**22/0001/LRB (Planning Ref: 21/01603/PP) –
Land South of High Oaks Artarman Road, Rhu Helensburgh**

**PROPOSED DWELLING HOUSE, ARTARMAN ROAD, RHU
LOCAL REVIEW REF: 22/0001/LRB**

Proposed Residential Property, Artarman Road, Rhu – Ref 22/0001/LRB

LOCAL REVIEW BODY REFERENCE 22/0001/LRB

Fig 2 Visibility Splays for Accesses on the Outside of Bends

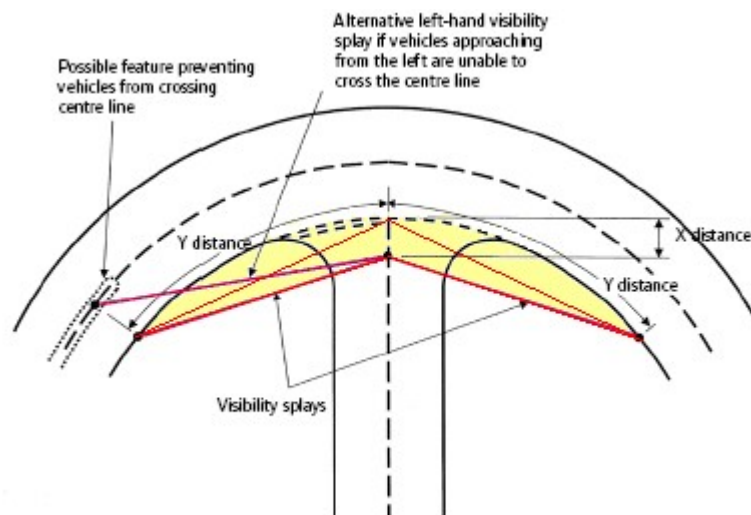
- f. The diagram provided by Roads Officers as part of the Roads Guidance for Developers is totally misleading with regards to this proposed development as it shows a sharp bend in a road which is clearly not the situation with this proposal on Artarman Road.
